JORDAN

JORDAN REVISION LIST - STRUCTURAL:

JORDAN REVISION LIST - ARCHITECTURAL:

FIRST FLOOR PLAN

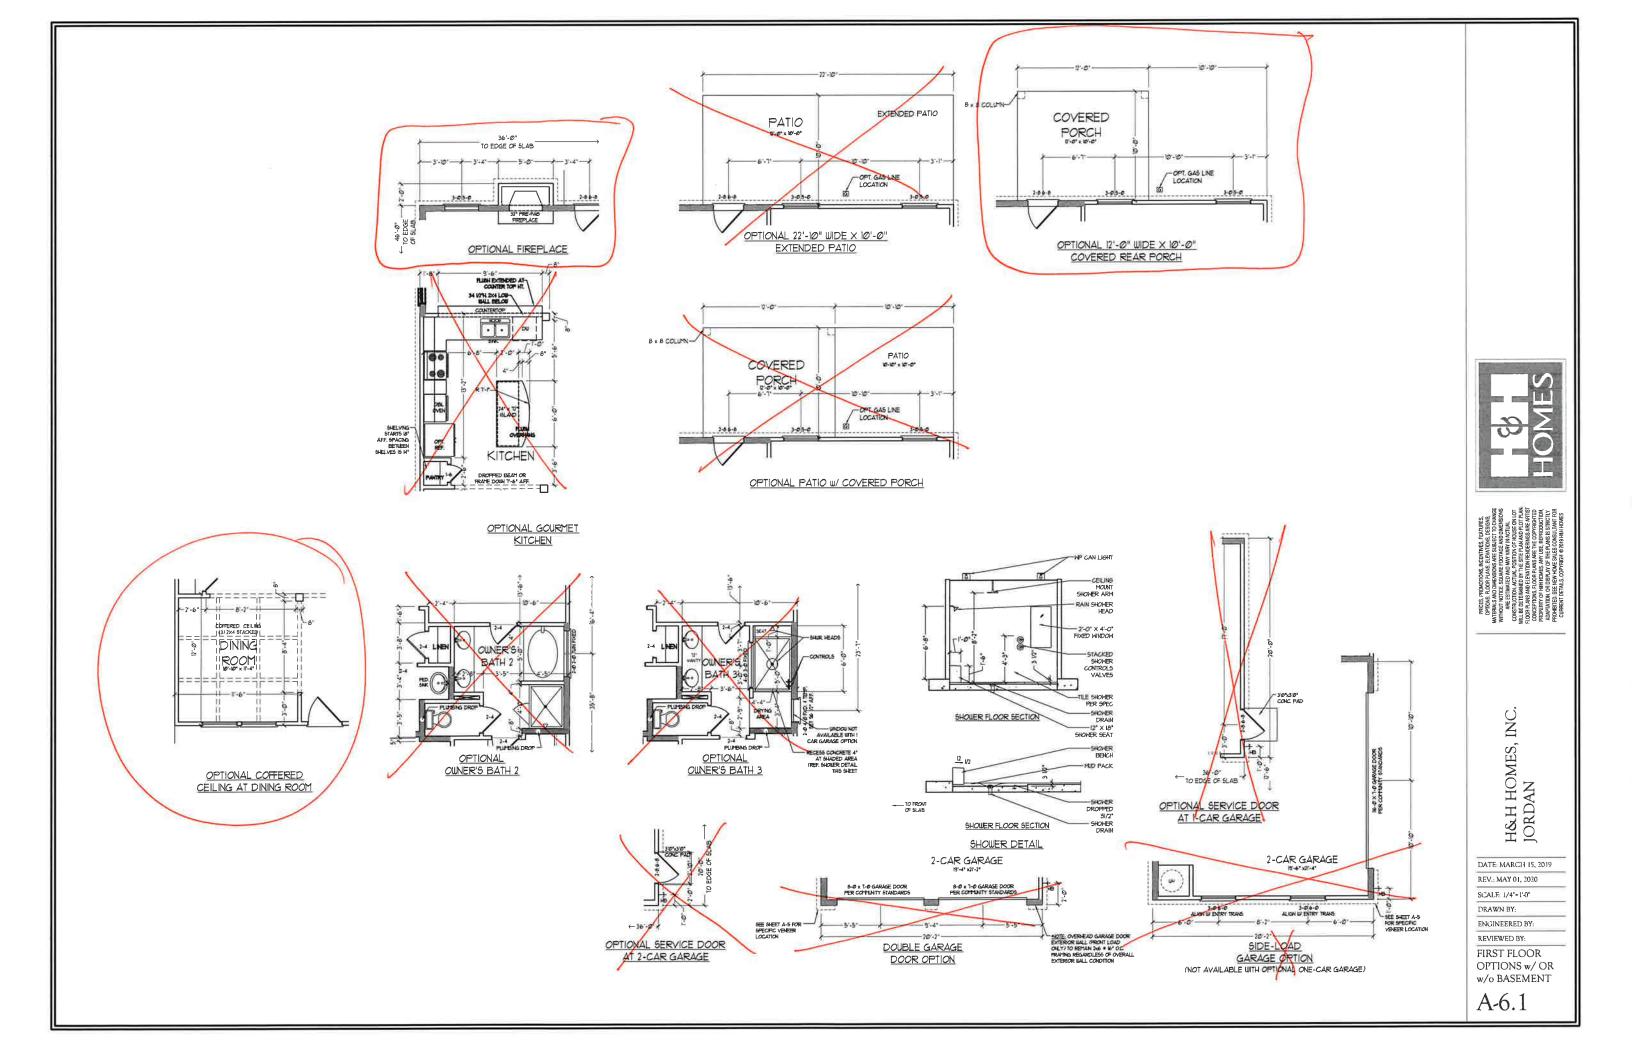
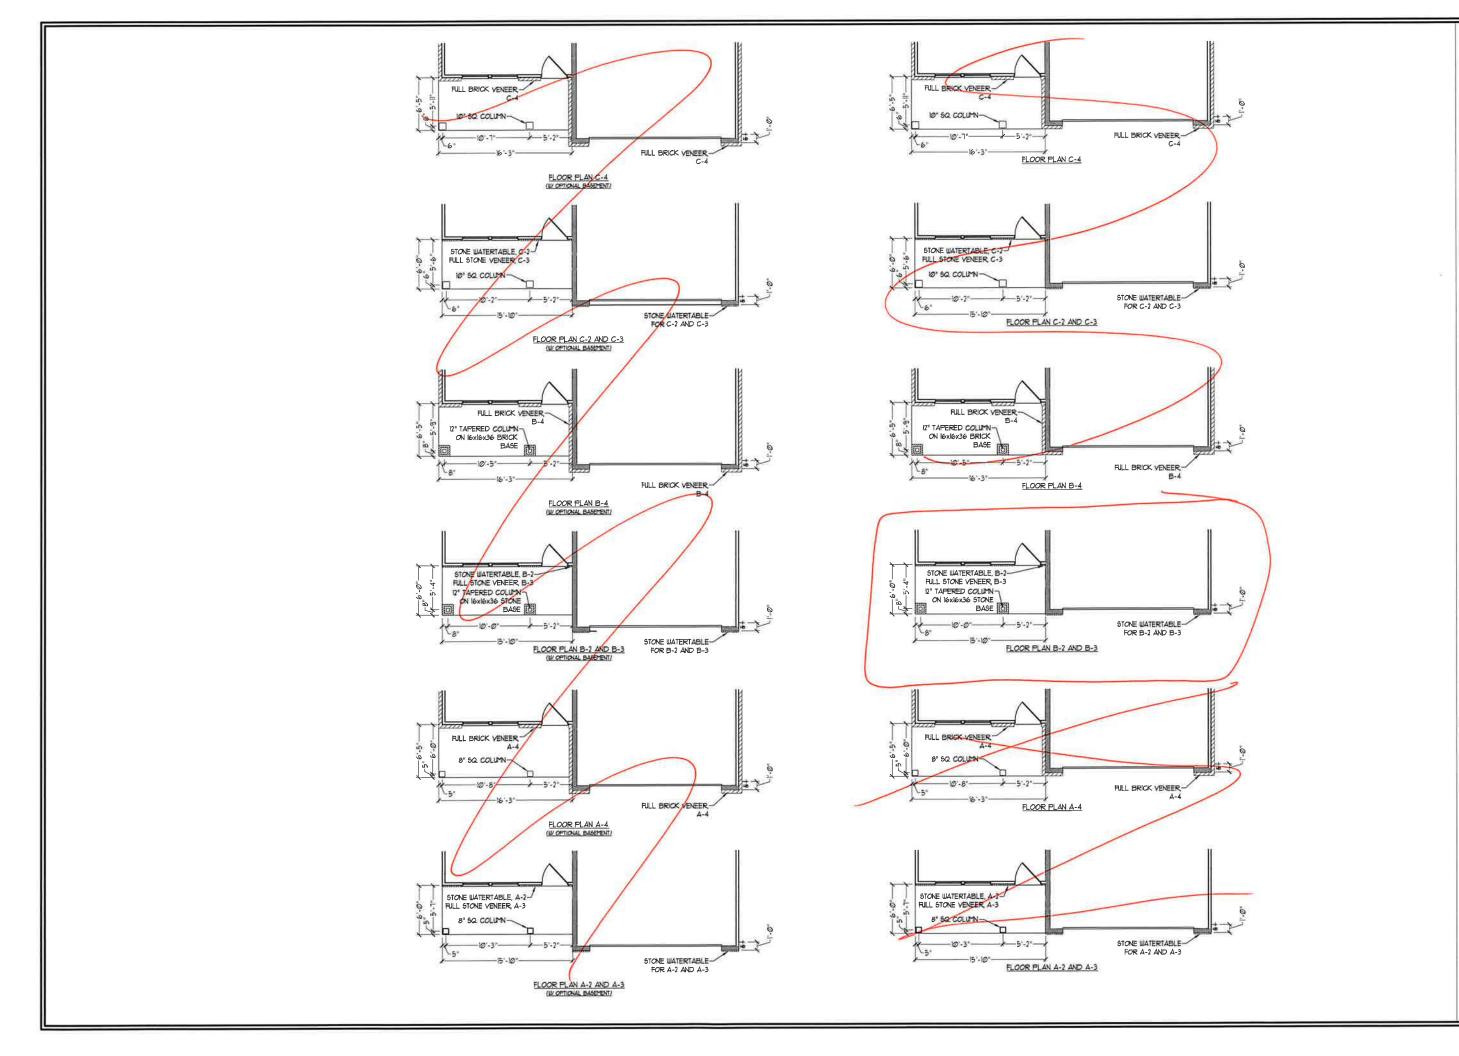
- CHANGED SWING OF SERVICE DOOR IN GARAGE TO OUT SWING (SEE SHEET A6.1) (7-8-20)
- REMOVED LIGHT IN SECONDARY BATH OVER TUB/SHOWER COMBO (7-8-20)
- 43. REMOVED "RECESSED ENTERTAINMENT BOX" OVER FIREPLACE (7-8-20)
